100 MAYFIELD PROJECT

FINAL EIR

Response to Comments and Text Revisions to the Draft EIR

LEAD AGENCY:
City of Mountain View
Community Development Department
500 Castro Street
Post Office Box 7540
Mountain View, California 94039-7540

FIGURE 4.12-13

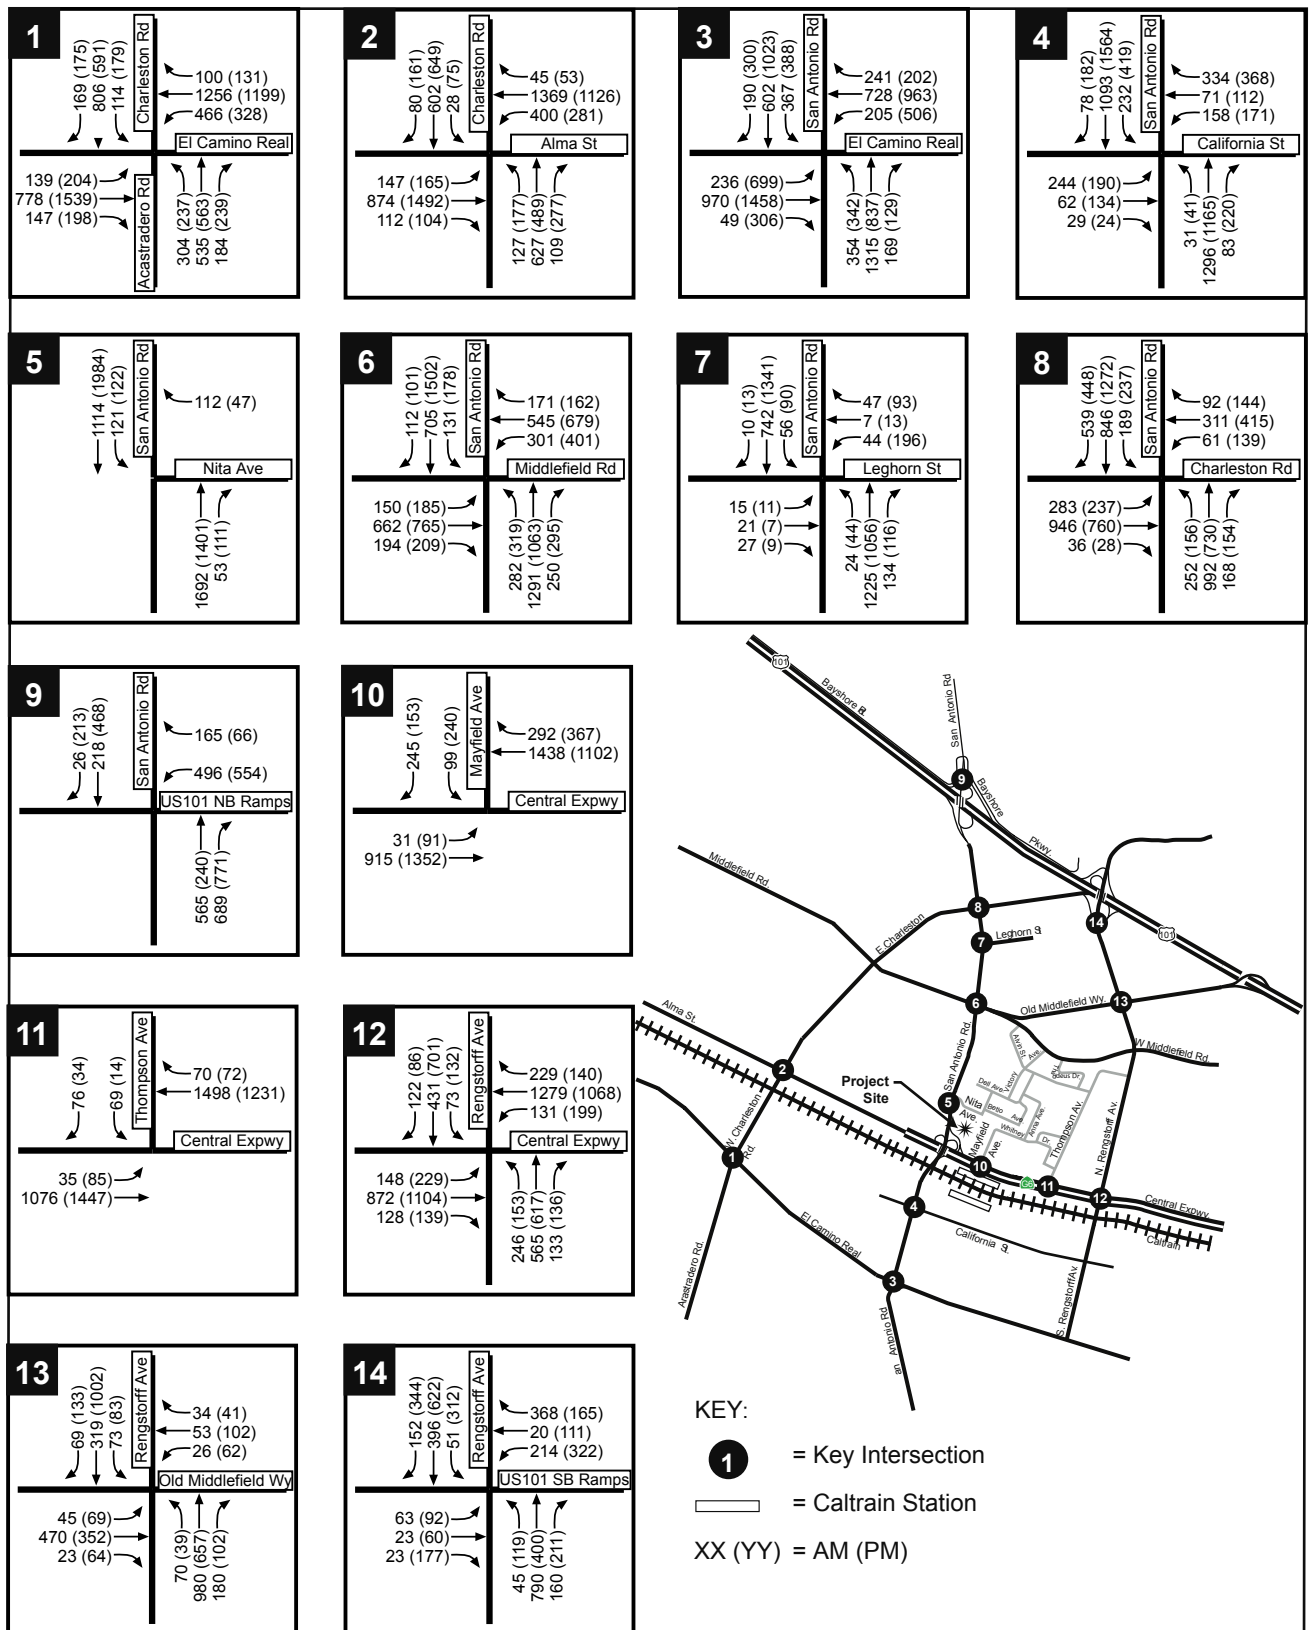
A commenter noted that counts conducted by community members between 4 and 7 PM showed higher left-turns at Central/Thompson than the numbers on **Figure 4.12-13**. [Riciputi (38a, 38h, EPC2-3)]

The traffic study evaluated the highest 1-hour volume measured during the AM (7-9) and PM (4-6) commute periods. This approach is consistent with Mountain View, Palo Alto, and VTA traffic impact analysis guidelines and is used because it focuses on the period of highest demand (traffic volume) which is the period when traffic impacts are the greatest. The volumes on **Figure 4.12-13** represent the highest 1-hour volume and would be less than the numbers cited by community members since those counts were conducted over a 3-hour period.

Figures 4.12-7 and **4.12-13** have been revised to show correct traffic volumes, in accordance with the text in the Transportation section of the EIR.
